**Re: Initial Submission Review - Rockinghorse Pool & Activity Center CSP 5 SP Amendment**  
Case Number: **2014-6036-03**

# ROCKINGHORSE POOL & ACTIVITY CENTER

## CONTEXTUAL SITE PLAN NO. 5

TITLE: SITE PLAN **1**  
DATE: MAY 1, 2020  
SHEET 2 OF 13

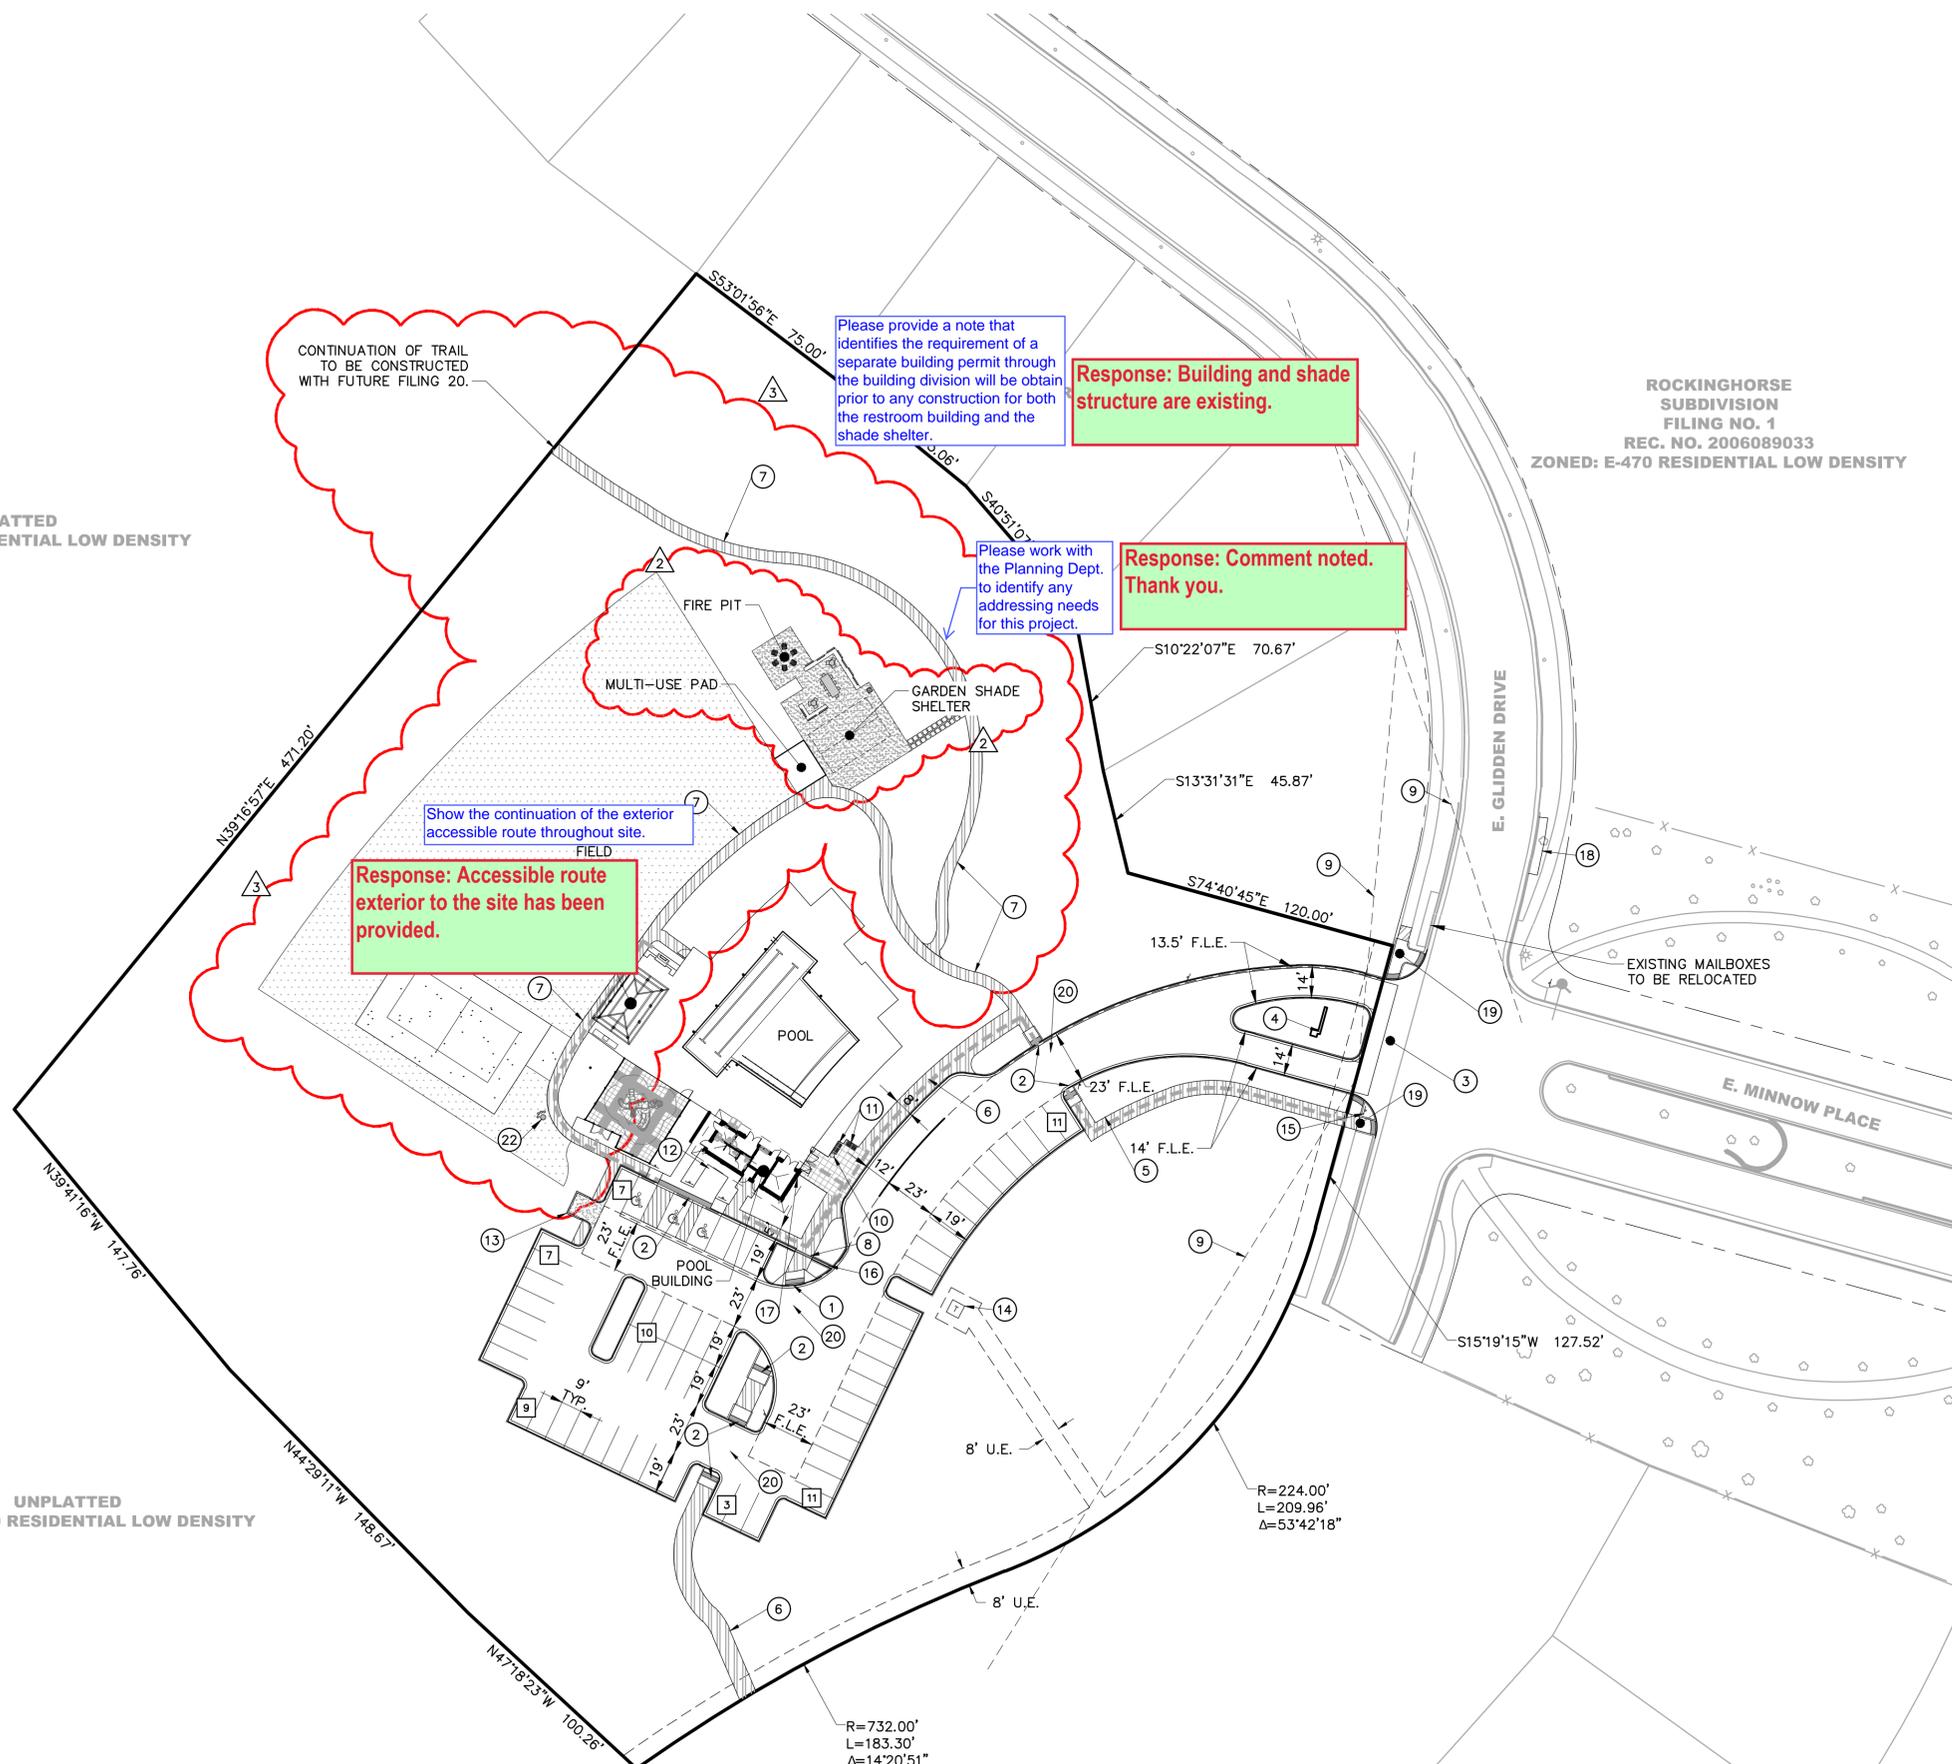
5. Please provide a note that identifies the requirement of a separate building permit through the building division will be obtain prior to any construction for both the restroom building and the shade shelter.

8. Show the continuation of the exterior accessible route throughout site.

**Response: Building and shade structure are existing.**

**Response: Accessible route exterior to the site has been provided.**

TITLE: GRADING/UTILITY PLAN  
 DATE: MAY 1, 2020  
 SHEET 3 OF 13

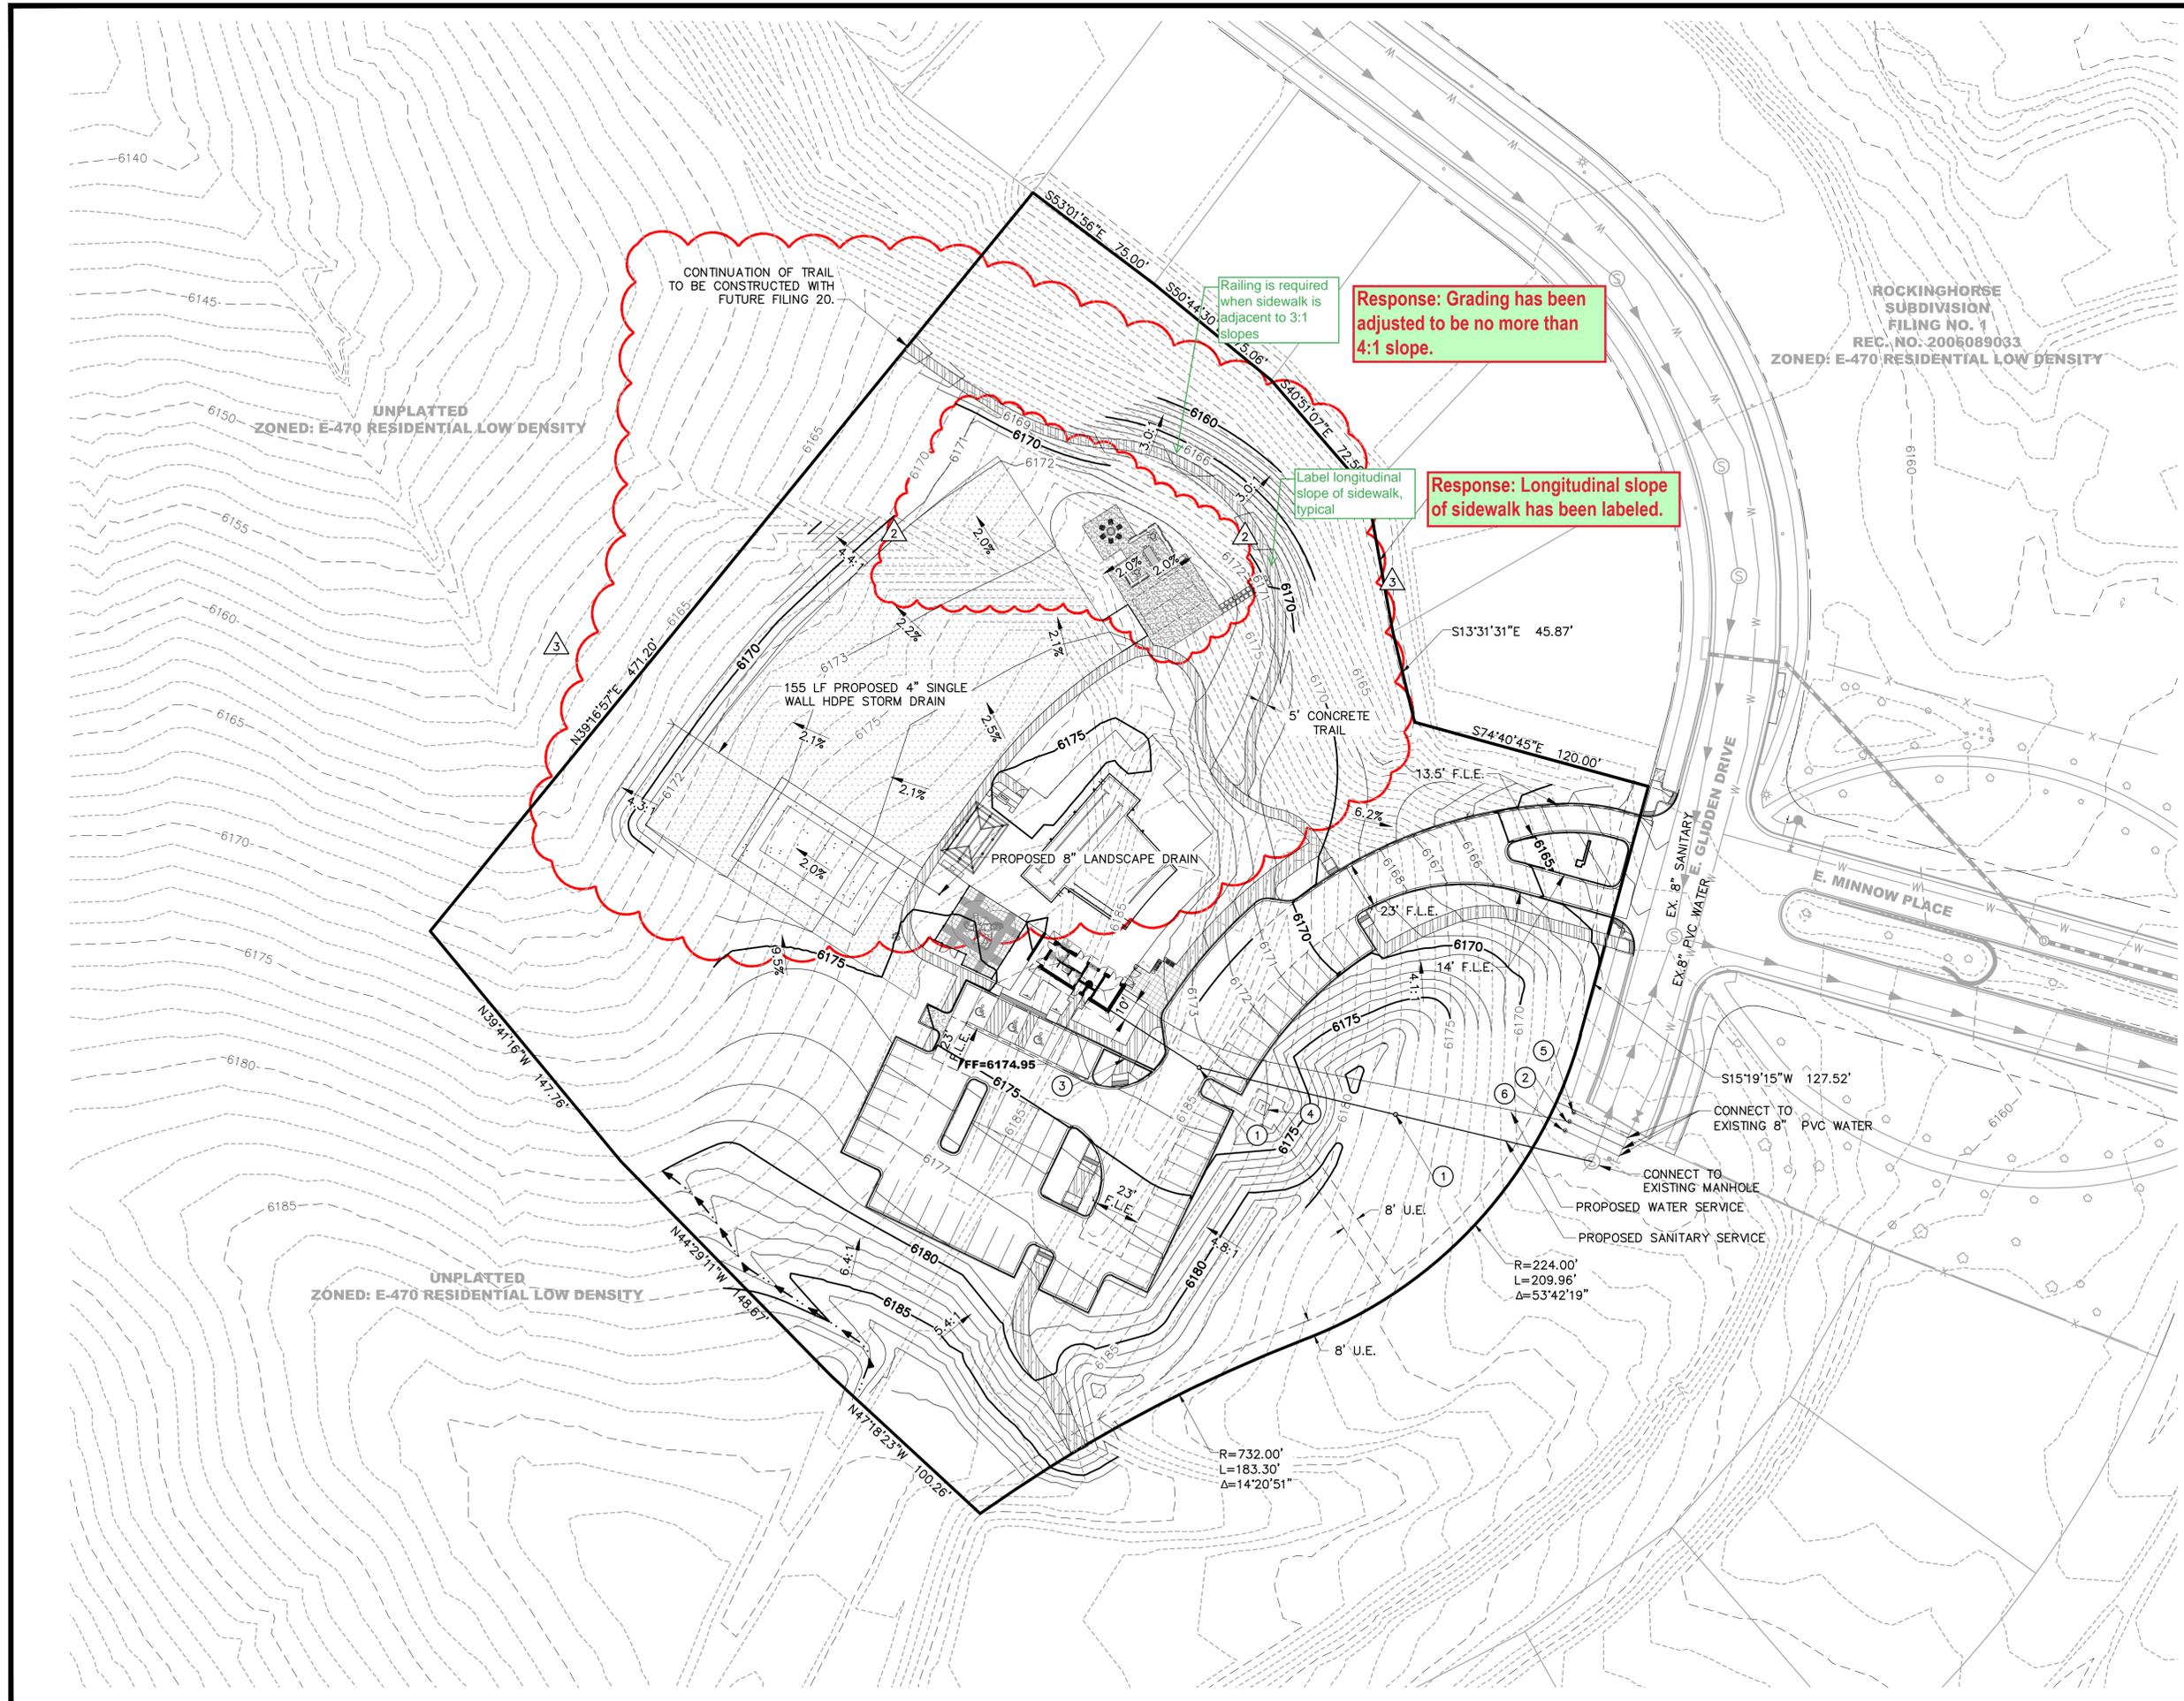
Railing is required when sidewalk is adjacent to 3:1 slopes  
**Response: Grading has been adjusted to be no more than 4:1 slope.**

Label longitudinal slope of sidewalk, typical  
**Response: Longitudinal slope of sidewalk has been labeled.**

SHEET TITLE: LANDSCAPE PLAN
SHEET NUMBER: L-04

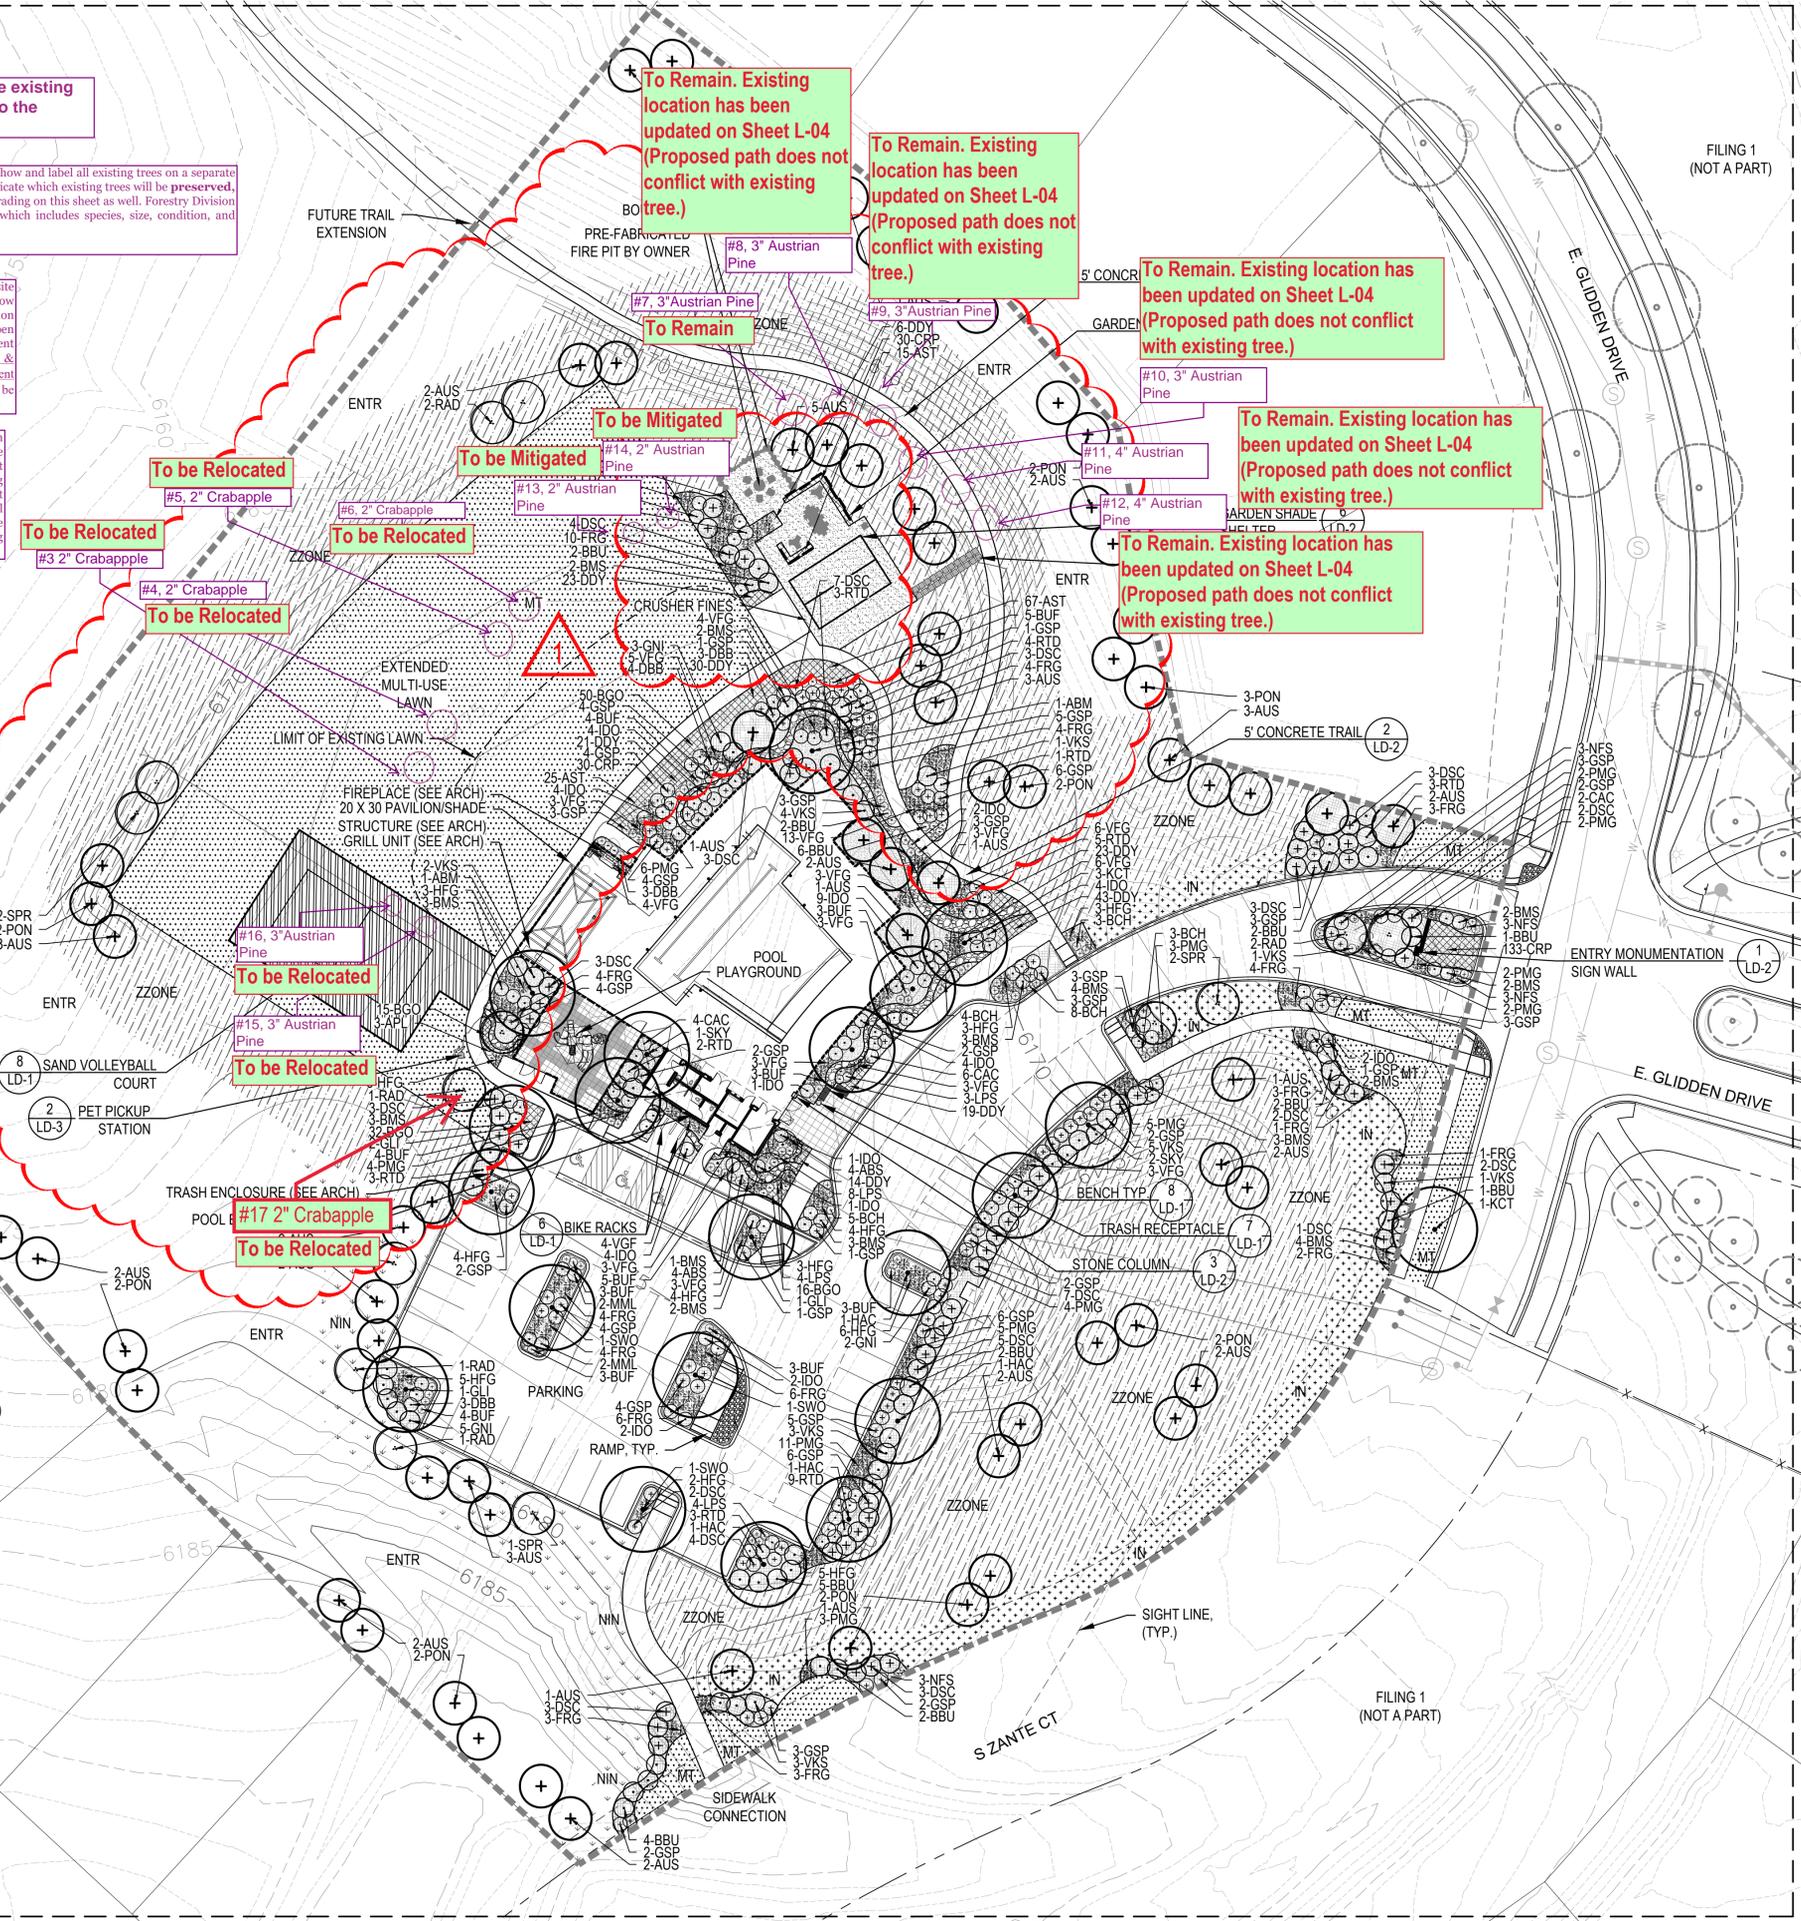
When the site plan is submitted, please show and label all existing trees on a separate sheet called Tree Mitigation Plan and indicate which existing trees will be preserved, removed or spaded. Please include grading on this sheet as well. Forestry Division staff has conducted a tree assessment, which includes species, size, condition, and location factors.

Any trees that are preserved on the site during construction activities shall follow the standard details for Tree Protection per the current Parks, Recreation & Open Space Dedication and Development Criteria manual. Parks, Recreation & Open Space Dedication and Development Criteria manual. These notes shall be added to the plan.

Please show a tree mitigation chart on the landscape plan taken from the Landscape Manual page 29. If payment will be made into the Tree Planting Fund, add another column to the chart indicating the payment amount that will be made. If trees will be planted on the site, please show a symbol indicating trees that are specific to tree mitigation.

Response: Thank you. Comment noted. Per conversation with Forestry on 06/12/2020 we will show existing tree locations and identify trees that will be removed, relocated, mitigated, or preserved on Sheet L-04 and identify quantities of existing trees in a Tree Mitigation Table on the Cover Sheet. Tree preservation notes have been added to the Cover Sheet. Proposed grading is shown on Sheet L-04.
